**TOWN OF DOVER
PLANNING BOARD MEETING**

Memorandum

To: Town of Dover Planning Board
From: AKRF, Inc.
Date: June 13, 2025
Re: 198 Dog Tail Corners Road – Special Permit for Accessory Dwelling
John Watson, P.E. (Applicant's Engineer)
cc: Kaitlyn Karcheski (Applicant's Representative)
Victoria Polidoro, Esq. (Planning Board Attorney)
Joseph Berger, P.E. (Planning Board Engineer)

OP-1

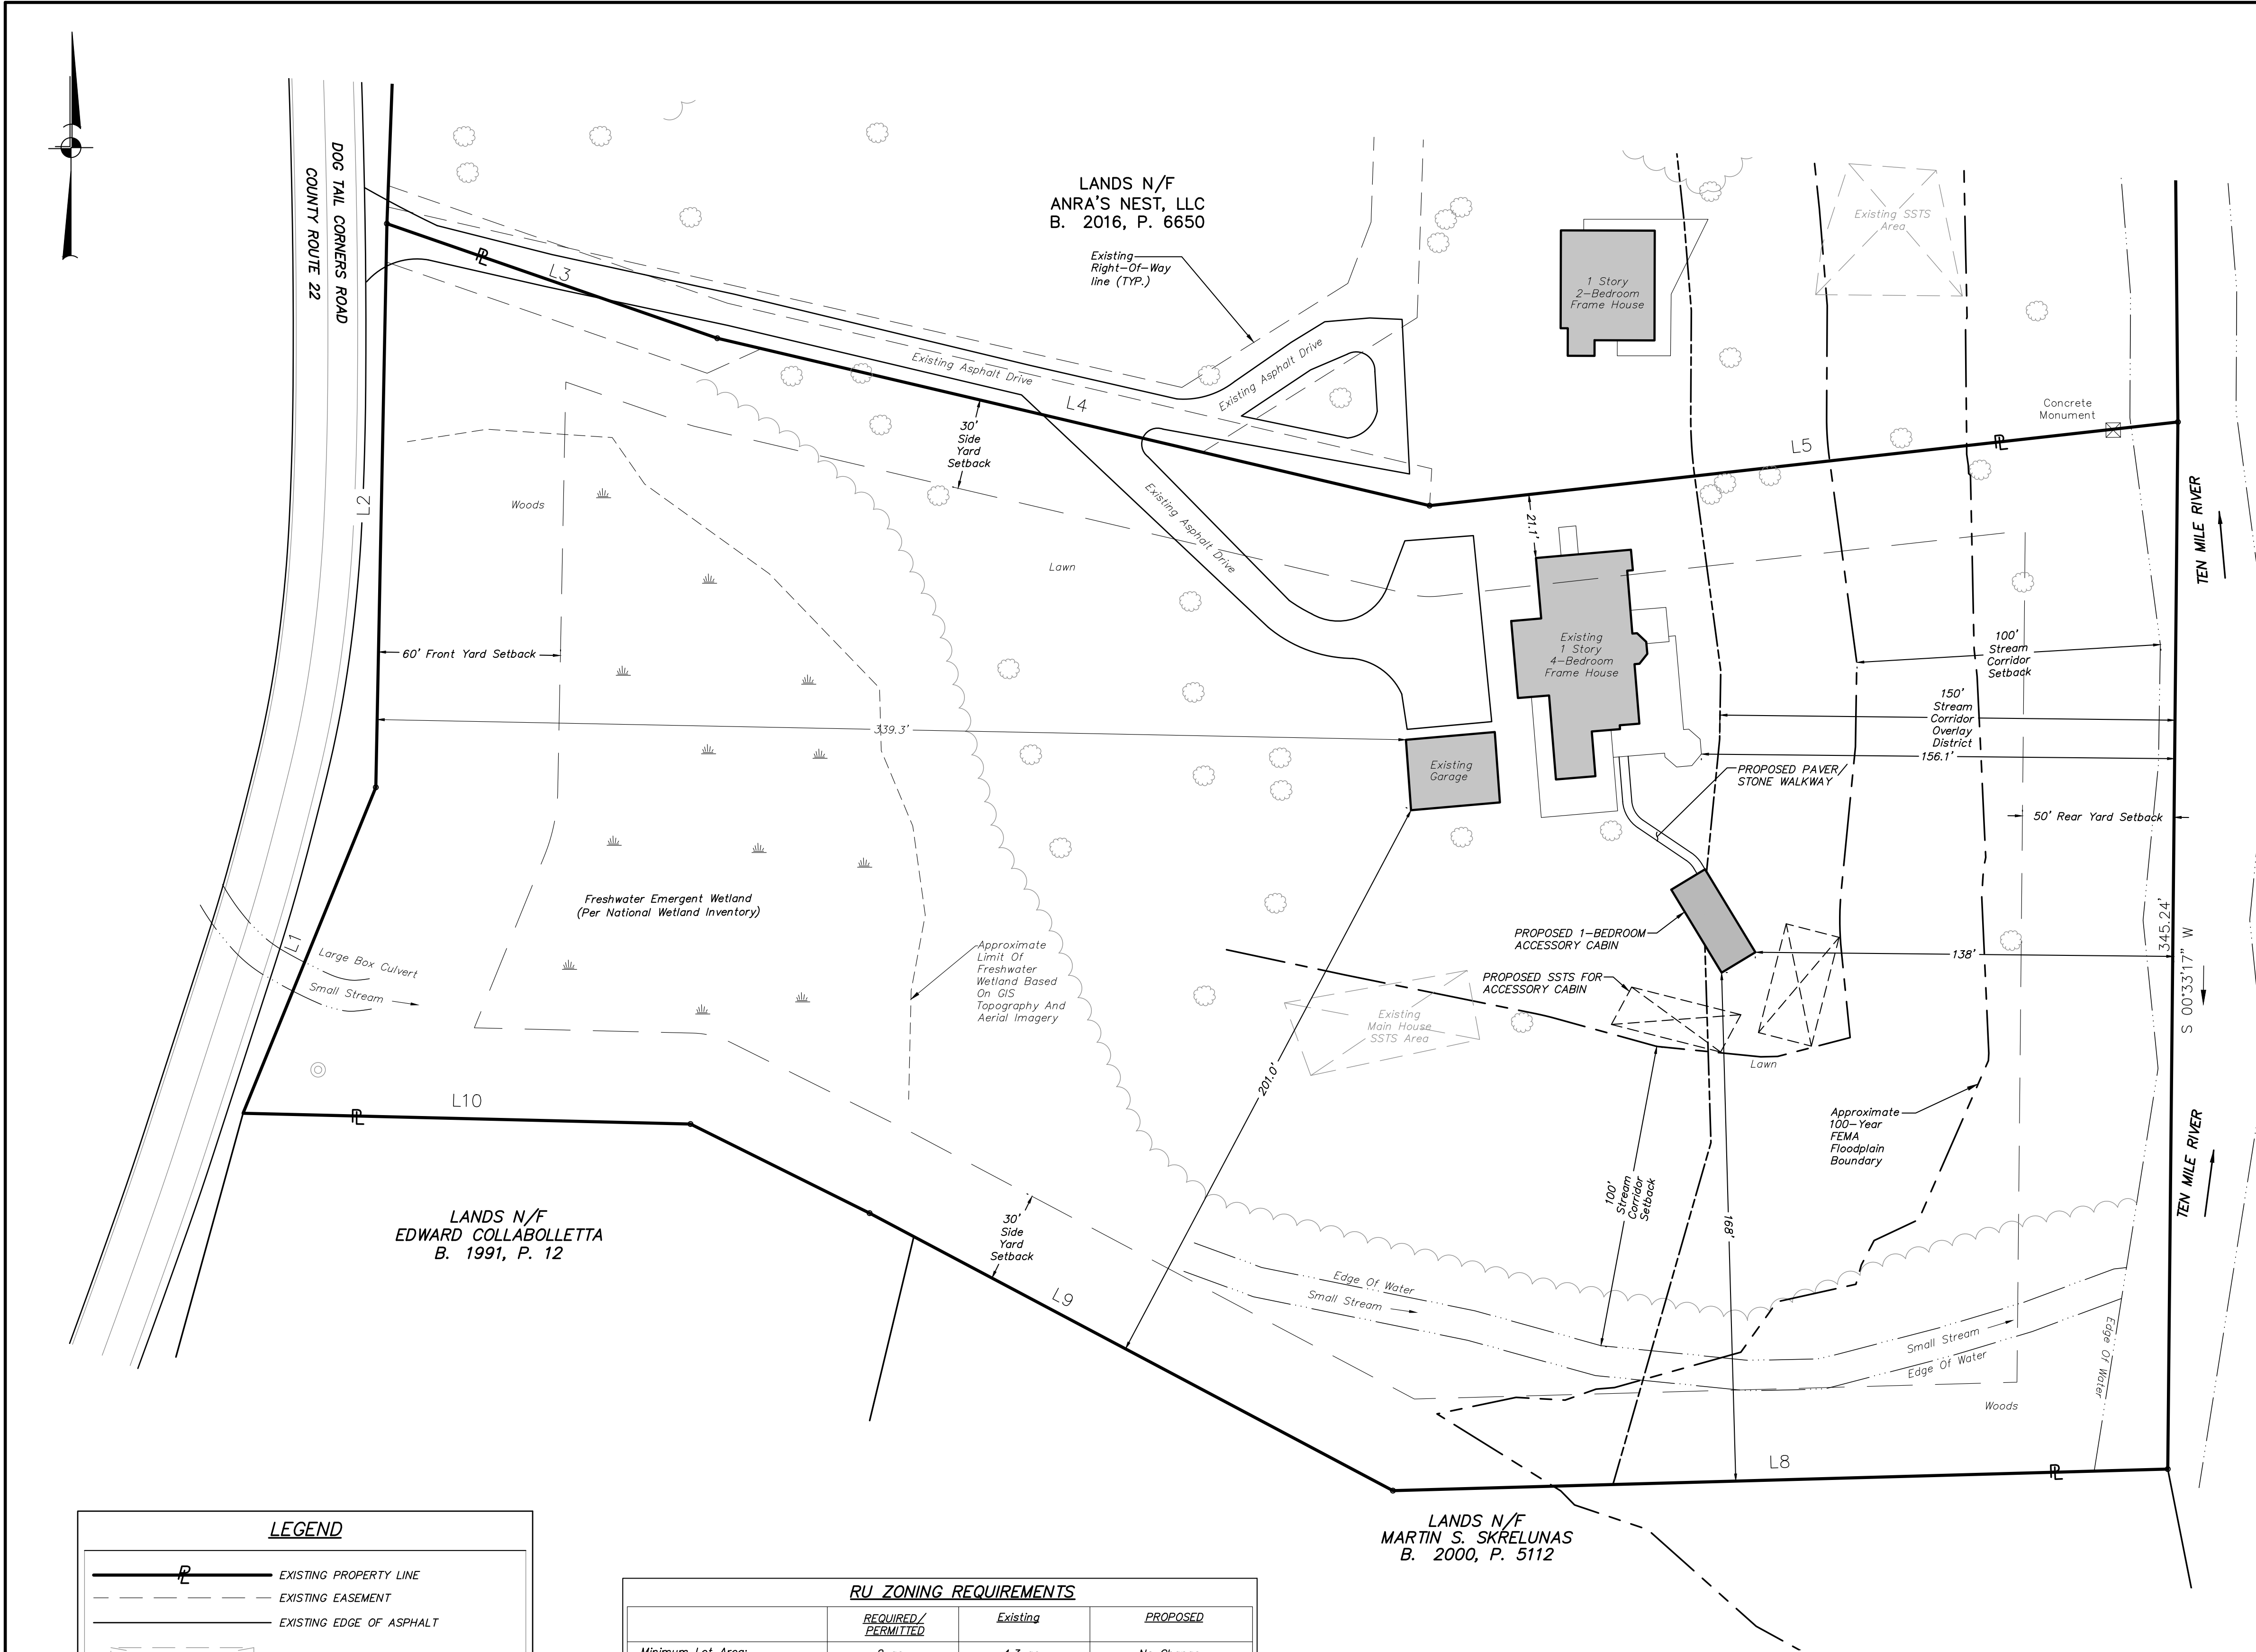
4. *2/28/2025: Since the subject property is within the Stream Corridor Overlay, a note should be added to the Site Plan that indicates any future development is subject to provisions/restrictions found at Section 145-14 of the Town of Dover Zoning Code. Additional comments related to the overlay are found below.*

5. *2/28/2025: Since the subject property is within the Town’s Aquifer Overlay District, specifically the Principal Aquifer Zone (PAZ). A note should be added to the Site Plan that indicates any future development is subject to provisions/restrictions found at Section 145-15 of the Town of Dover Zoning Code.*

6/13/25: Comment addressed. General Note #8 has been added to Drawing OP-1 on the revised site plan set.

6/13/25: Comment addressed. General Note #9 has been added to Drawing OP-1 on the revised site plan set.

DRAWING: **SITE PLAN**

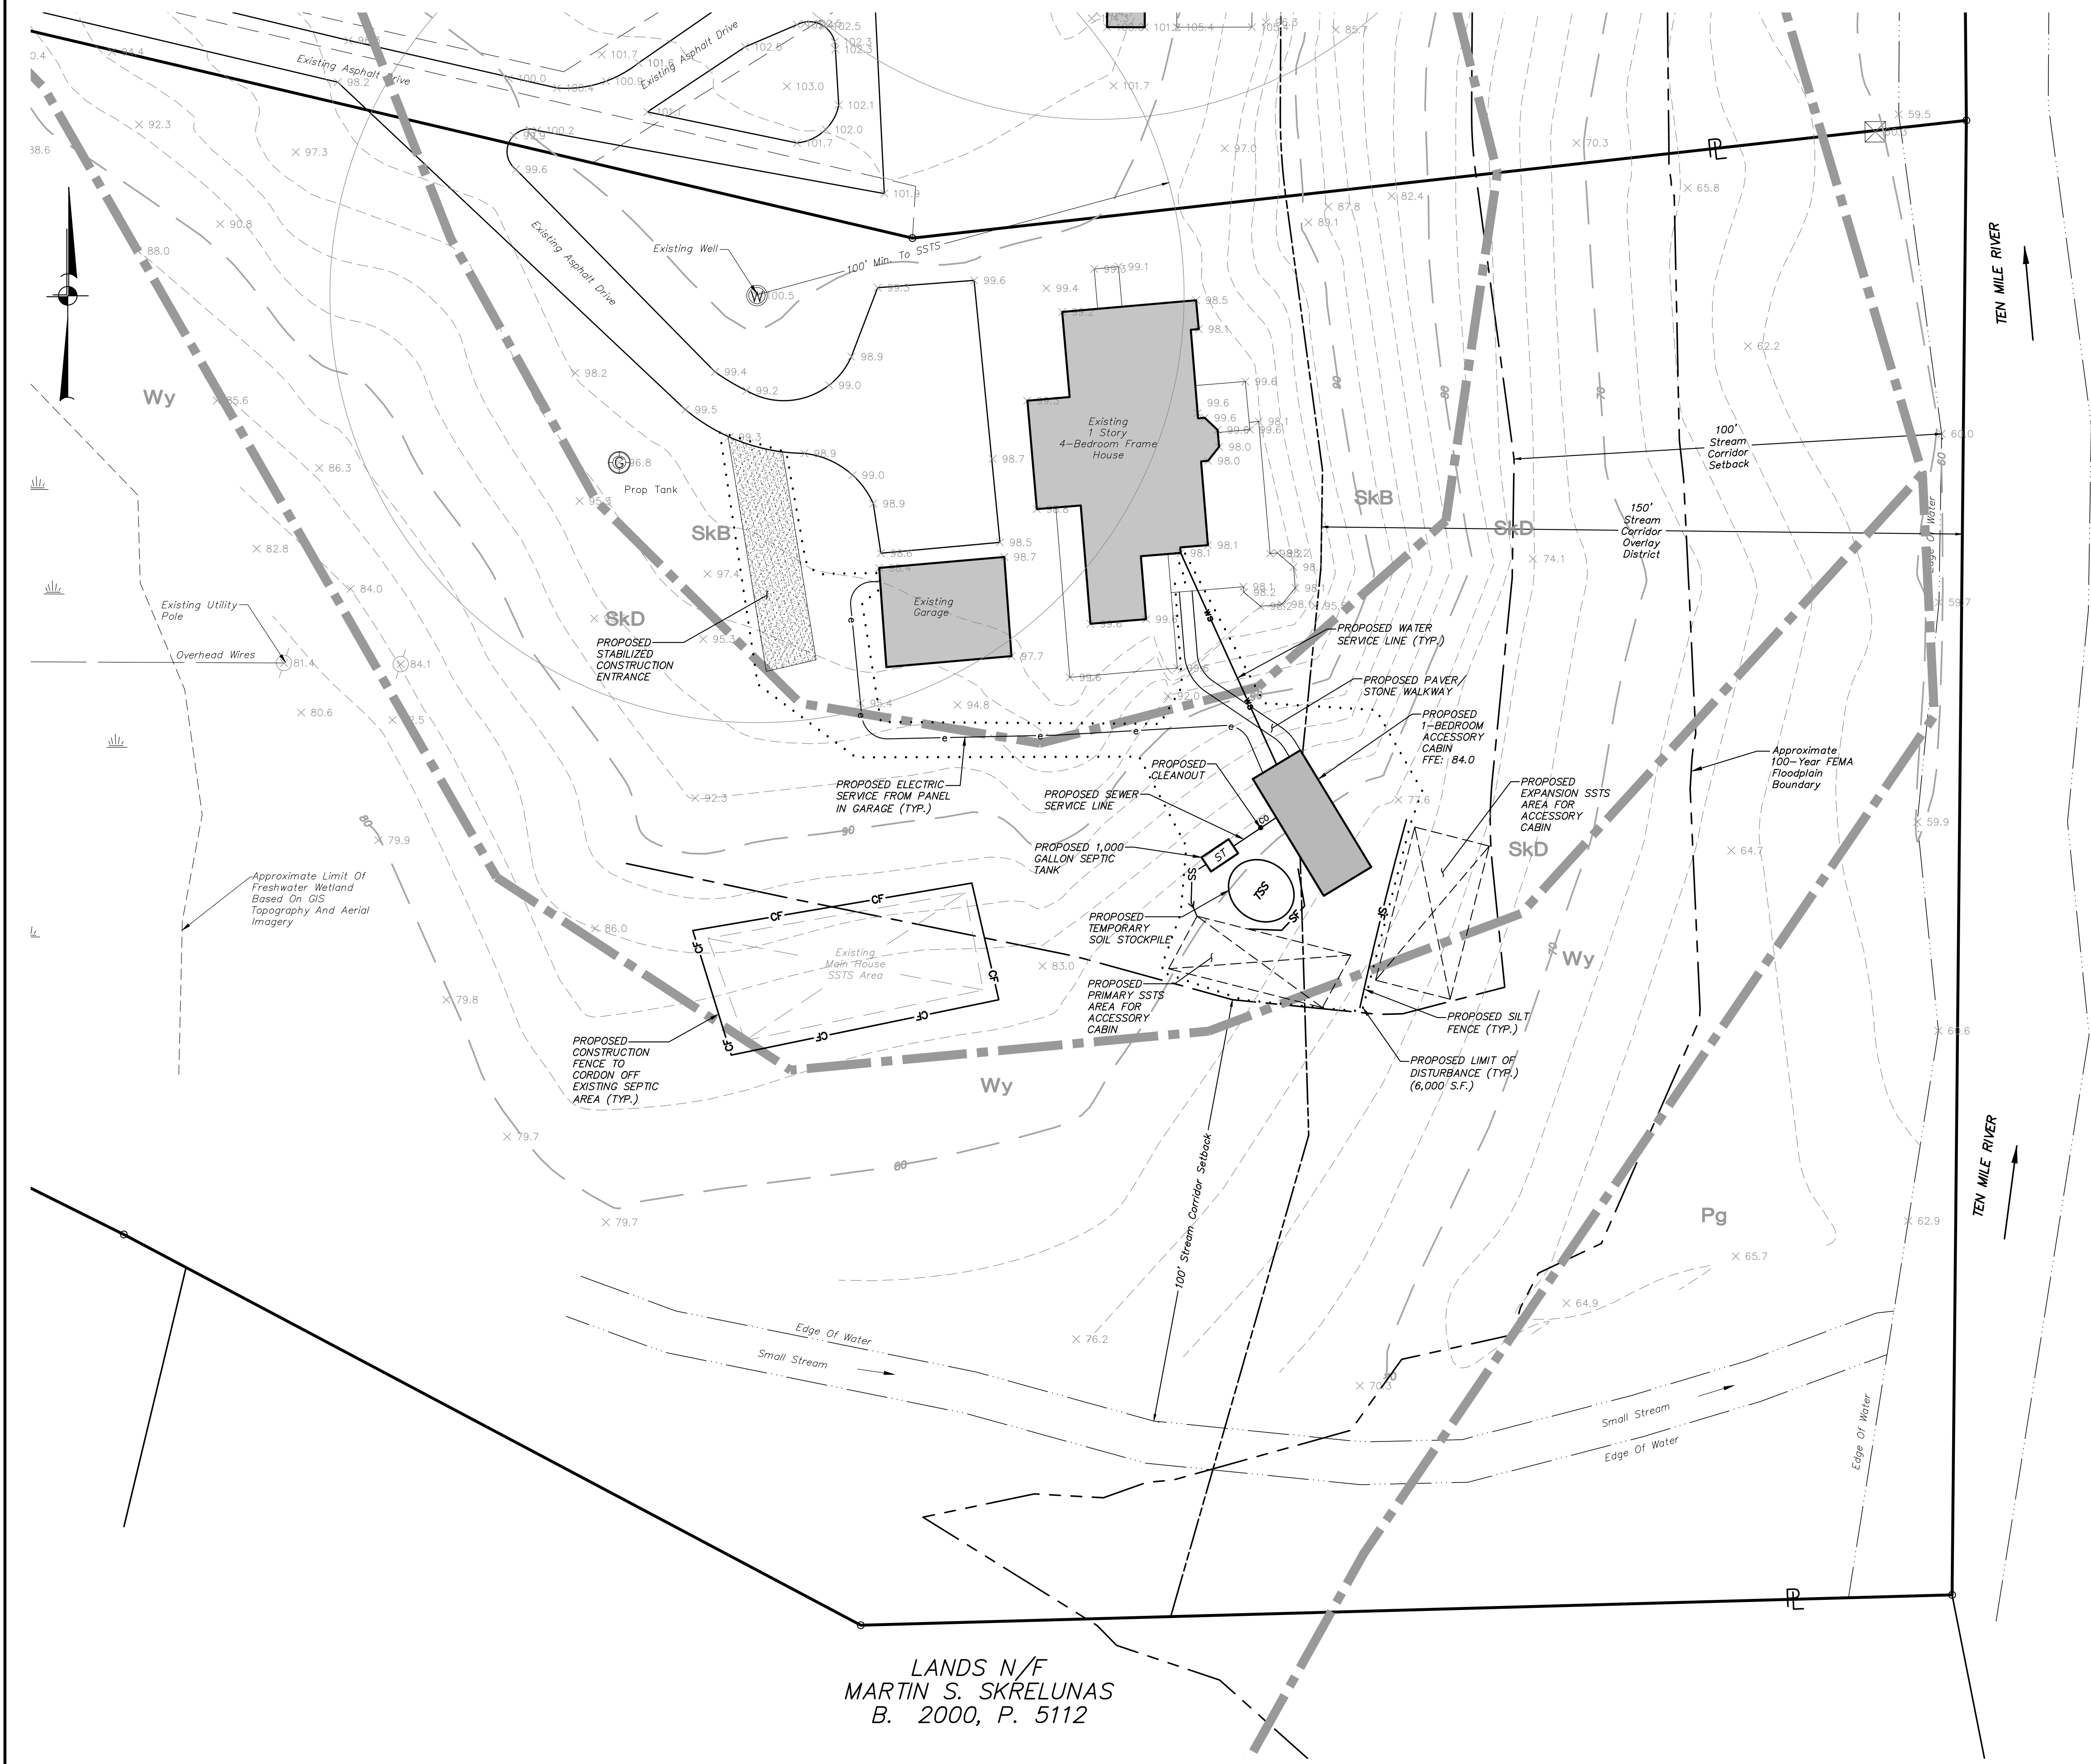
3. *2/28/2025: As shown in the Bulk Regulations table on the Site Plan drawing, the primary residence and the proposed accessory cabin appear to meet all yard setback requirements for the RU district.*

7. 2/28/2025: The subject property requires 4 total parking spaces pursuant to §145-38A(2) of the Zoning Code. The existing and proposed condition depicted in the Site Plan set shows adequate space exists for these parking spaces.

6/13/25: Comment acknowledged, no further comment.

6/13/25: Comment acknowledged, no further comment.

1,000 GALLON SEPTIC TANK DETAIL
(N.T.S.)

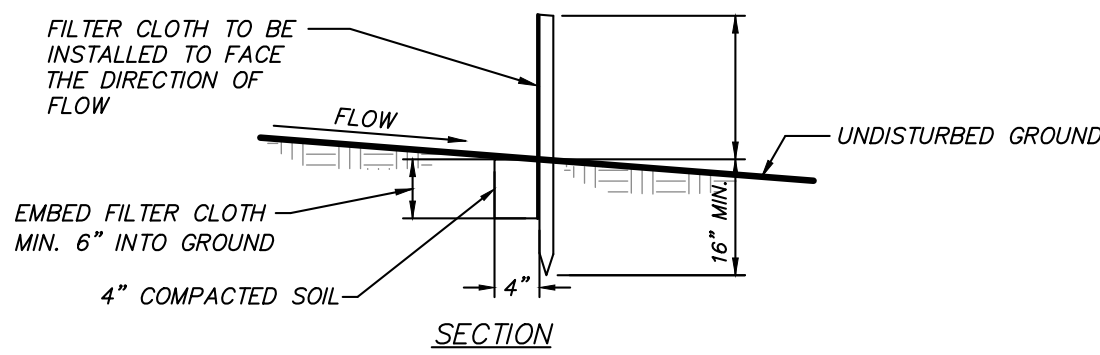
1. *Plans show a proposed septic tank and the narrative states a new onsite subsurface sewage treatment system is being proposed. Is it the plan to connect to the existing SDS or is a new SDS proposed. If a new SDS is proposed the design needs to be shown. If the existing SDS is being used does it have capacity for the additional structure being proposed*
The site plans have been revised to show the proposed subsurface sewage treatment system.
2. *If a new SDS is proposed the area of disturbance will be increased and additional erosion control may be needed*
Erosion and sediment control facilities are proposed downhill of all proposed soil disturbance activities to prevent the migration of sediment into the downstream receiving waterbodies.
